Product Change Notice (PCN)

PCN Number: PCN-0539028R-01

Product(s) Affected: CBL-UA-MB-1

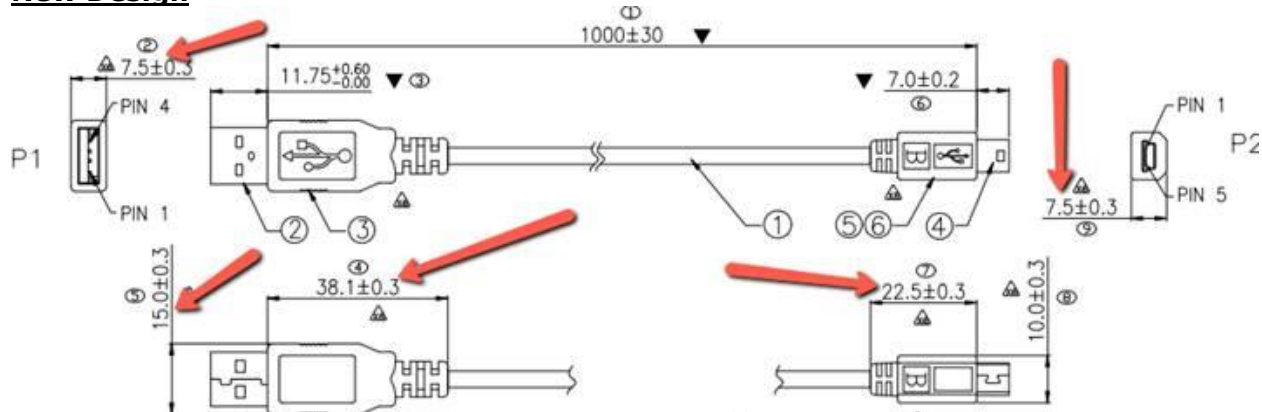
Reason(s) for Change: Old overmold mold cannot maintain efficient production. Adjustments necessary for efficiency purposes of automated production.

Description of Change: Adjustments shown in below images. Cable OD change to 3.5mm.
